**DOCUMENT 00 90 00  
ADDENDUM**

**ADDENDUM NO. [1]                      Date: March 13, 2020**

**RE:                      SCHOOL DISTRICT OF HOLMEN  
                             HIGH SCHOOL ADDITION AND REMODELING PHASE 2  
                             1001 McHUGH ROAD  
                             HOLMEN, WISCONSIN 54636  
                             HSR 18061**

**A310**

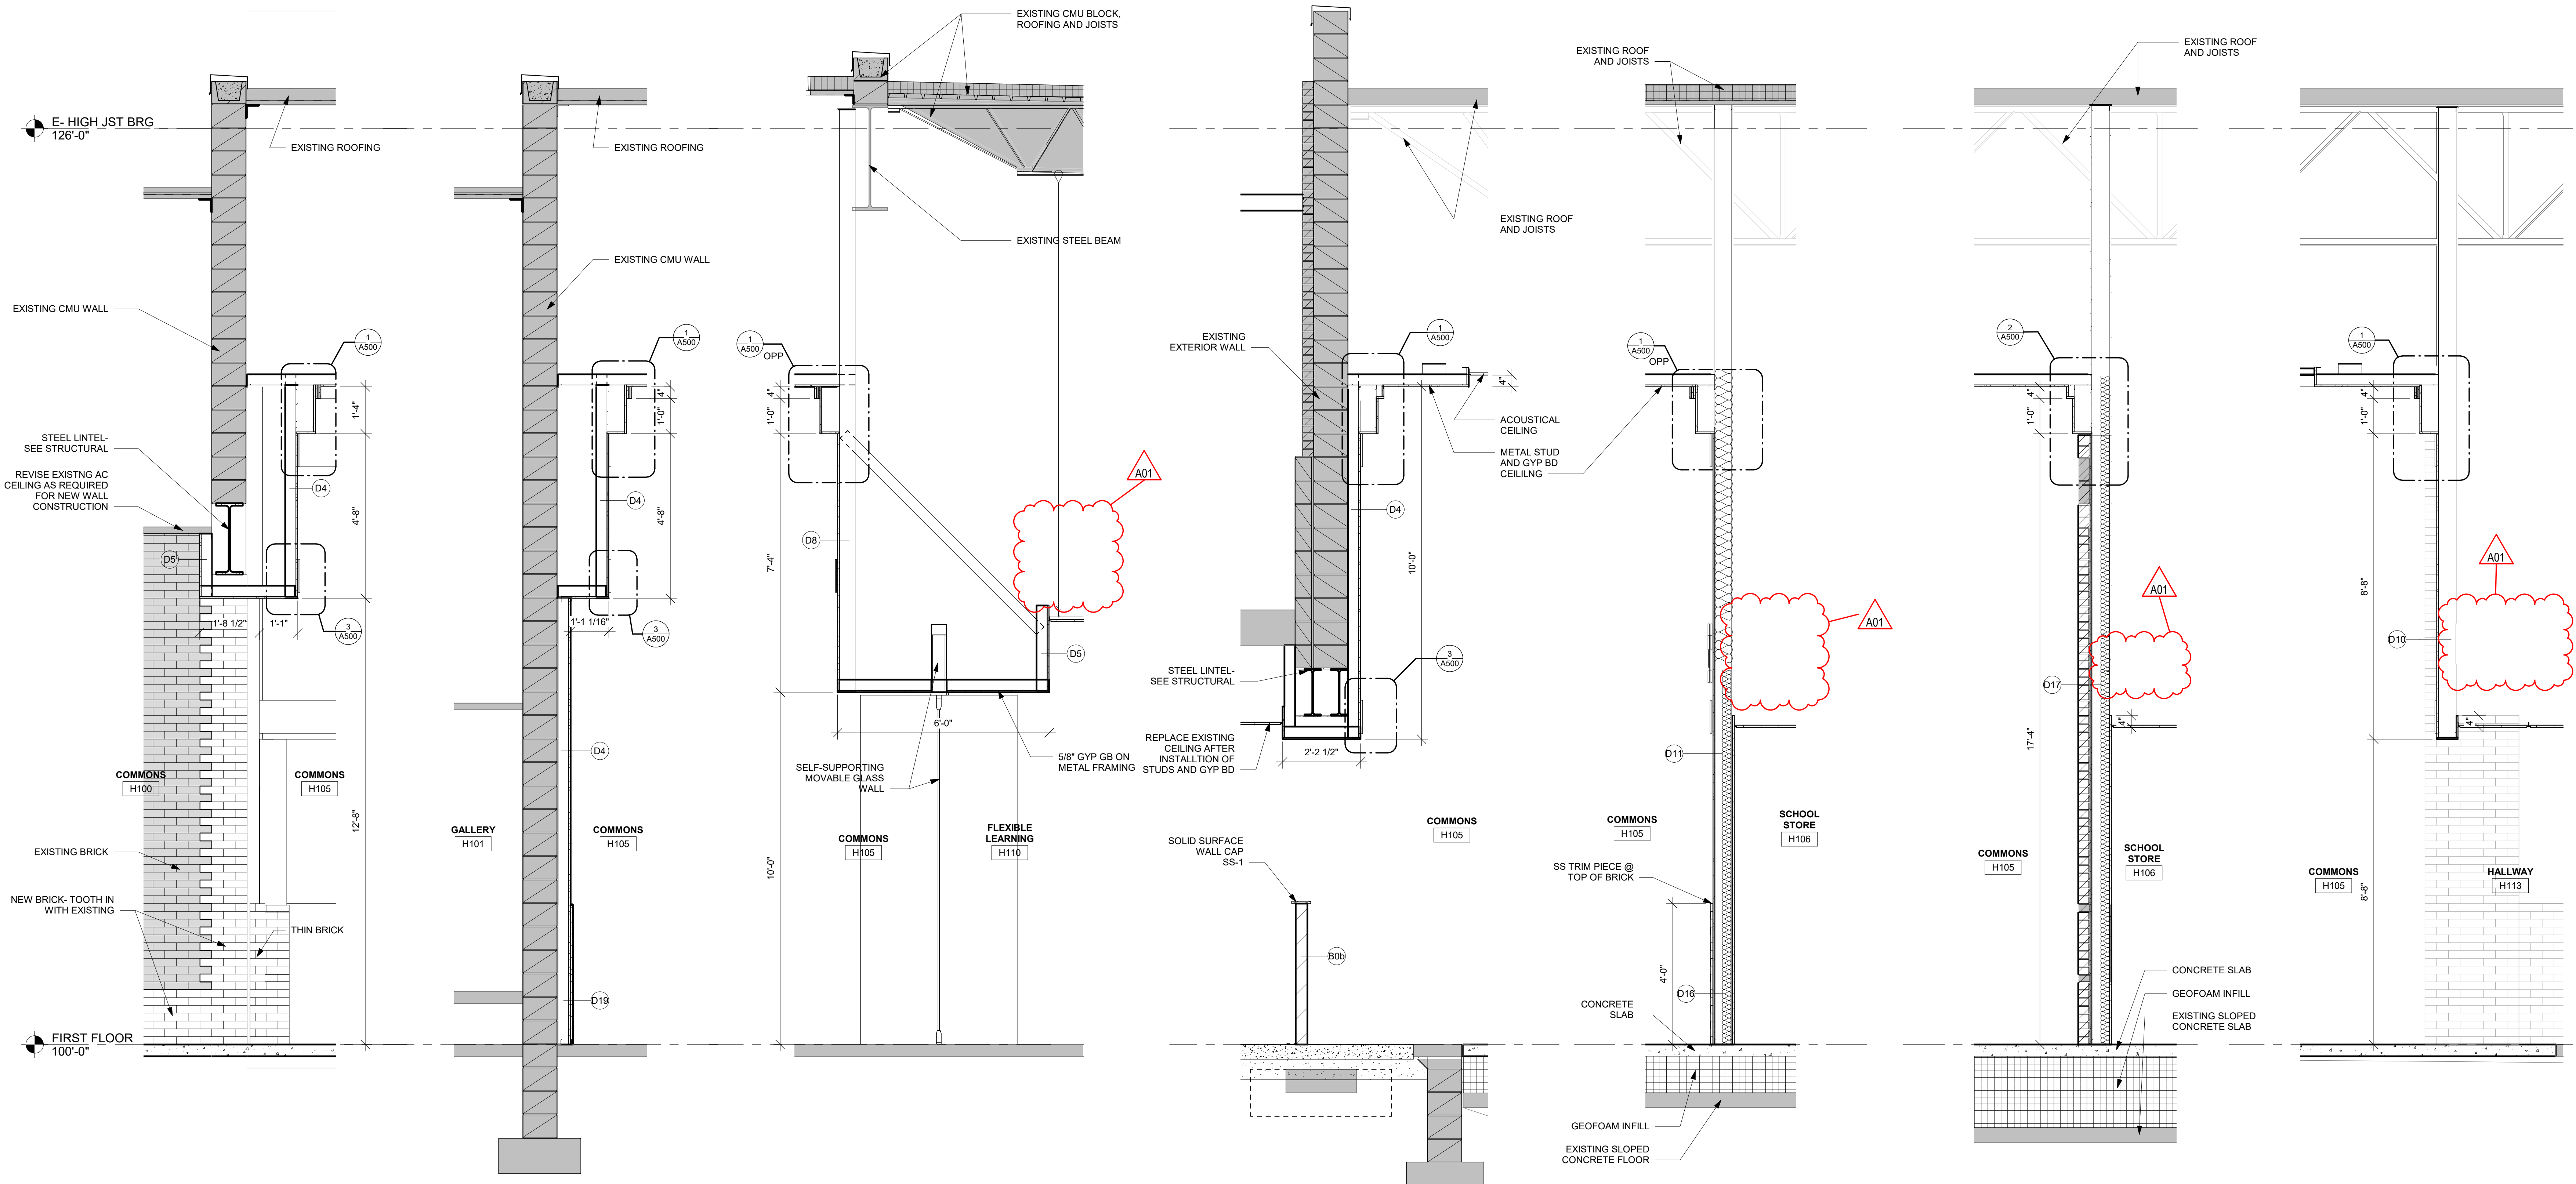
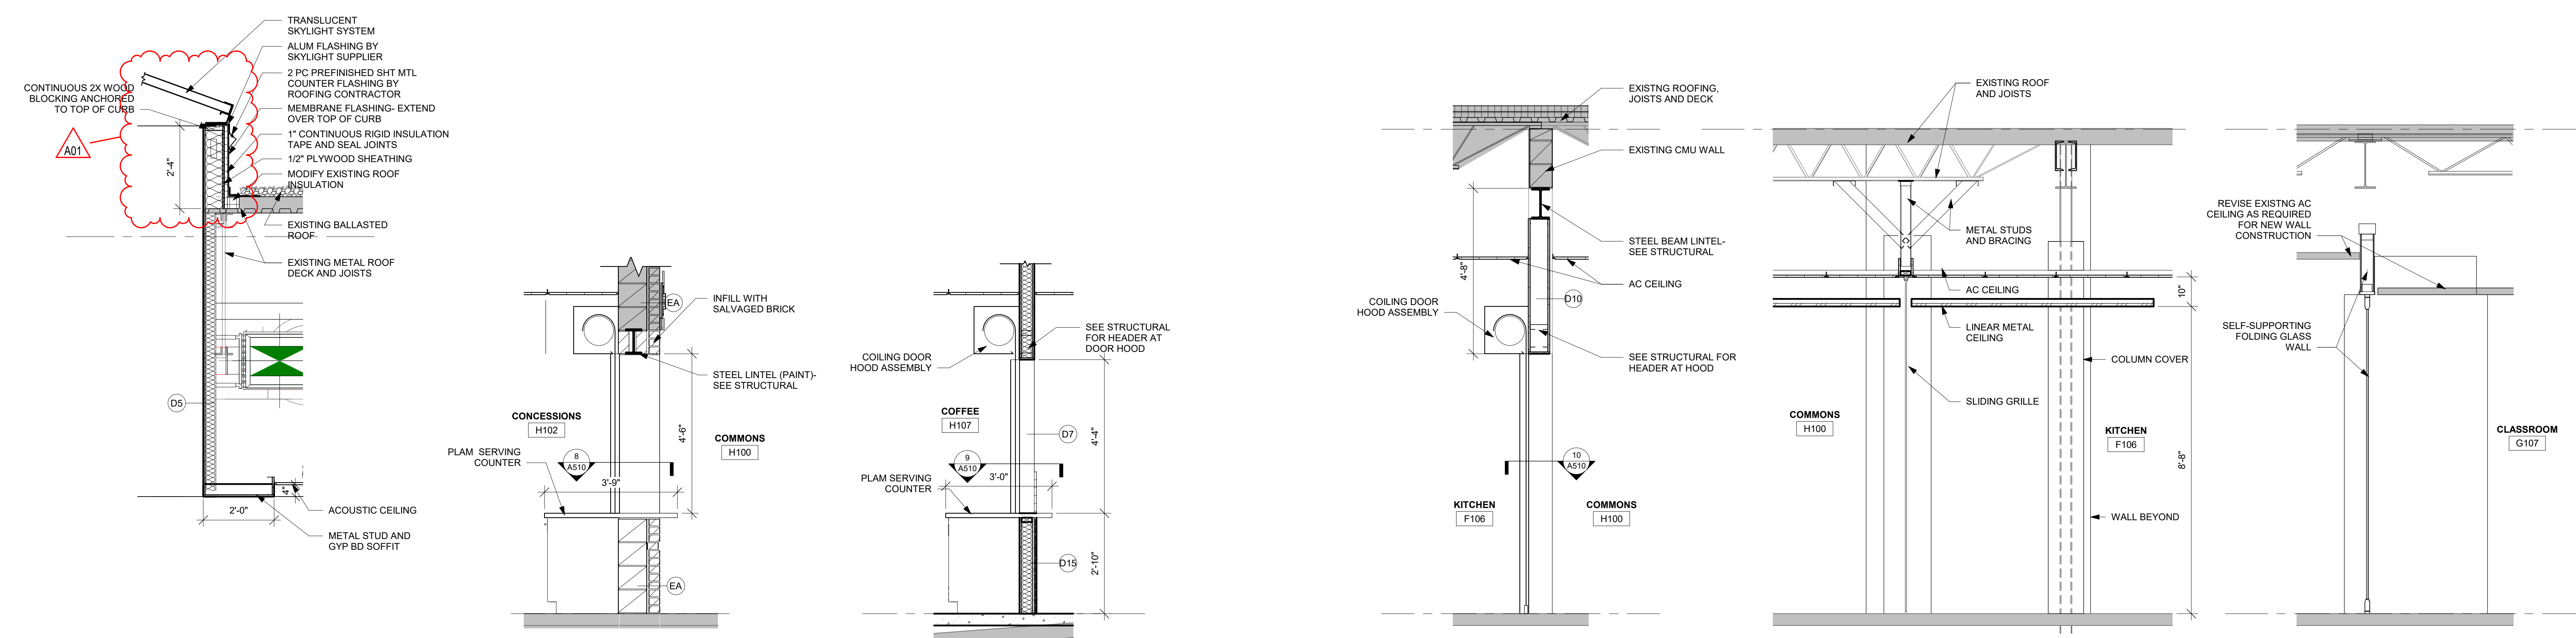
- a. Revisions clouded on Drawing.
- b. 3, 5, 6, 7A310; Delete secondary ceiling support. Suspend ceiling from structure above.
- c. 8A310; Revised skylight curb to meet install requirements.

**1 MEZZANINE DUCTWORK REMOVAL PLAN**  
1/8" = 1'-0"

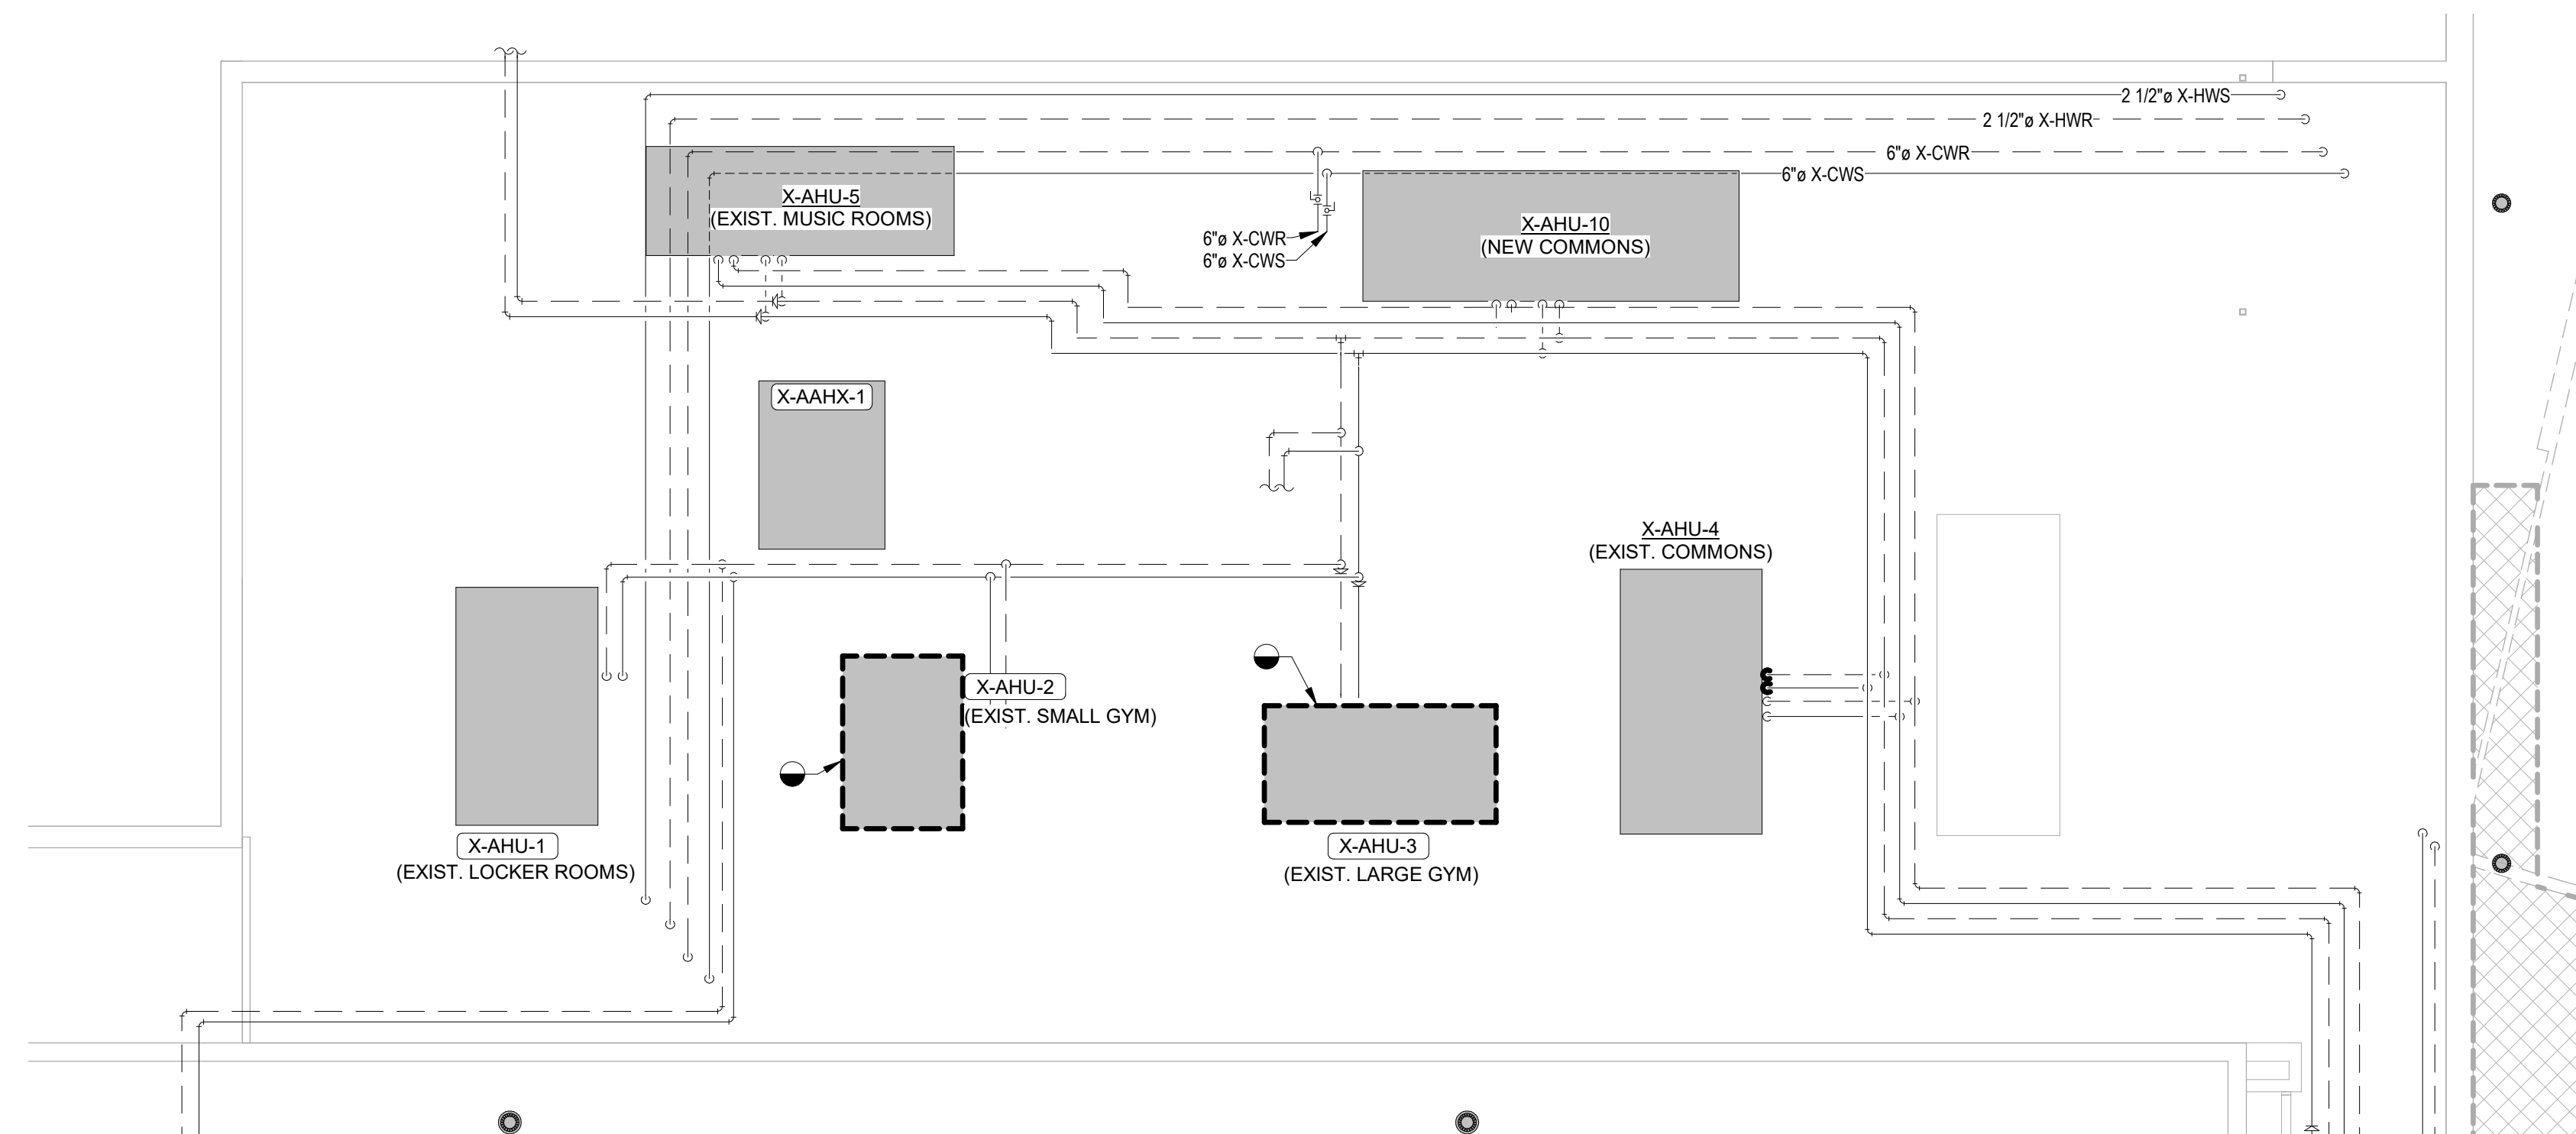
28. Sheet M092 ENLARGED MEZZANINE REMOVAL PLAN 30 x 42 attached hereto.
  - a. Drawing attached hereto shall be included in contract documents.
  - b. Indicating the removal of two (2) existing AHUs in the Mechanical Mezzanine Room.

**M092**

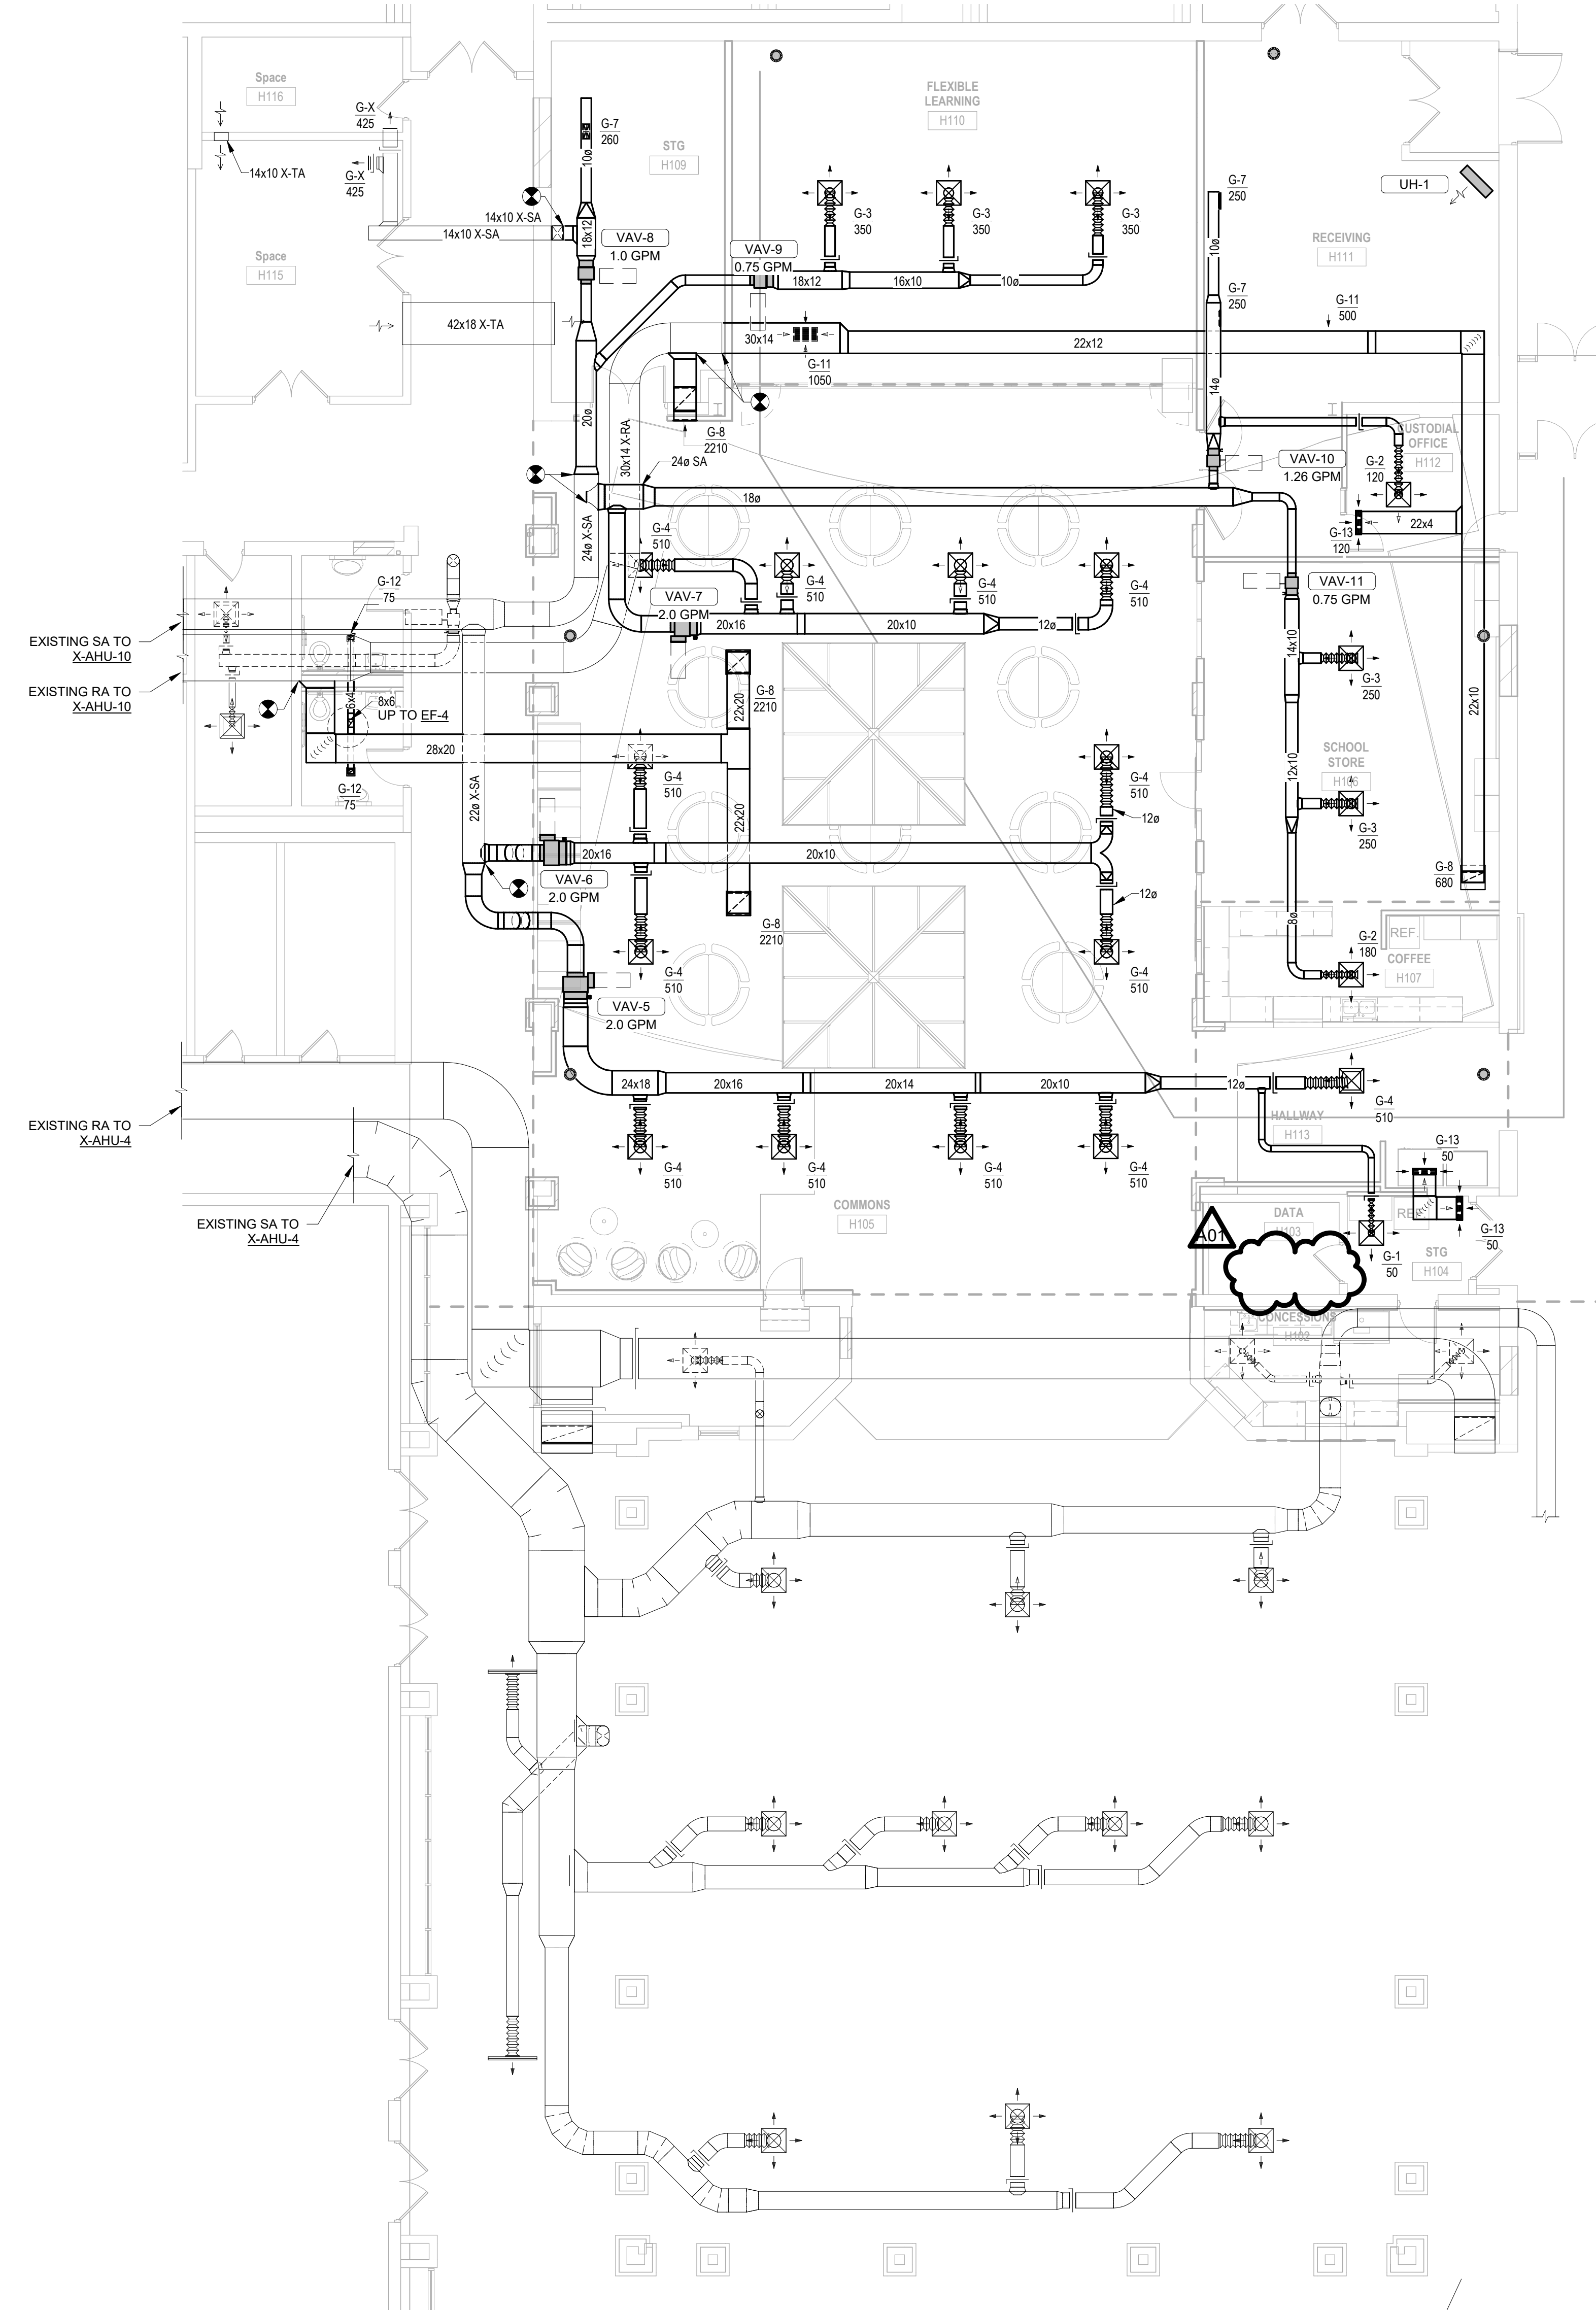
29. Sheet M103 MECHANICAL DUCT REMOVAL PLAN – SEGMENT H 30 x 42 attached hereto.
  - a. Revisions clouded on Drawing.
  - b. The mini-split unit is no longer required per IT. Unit has been removed.
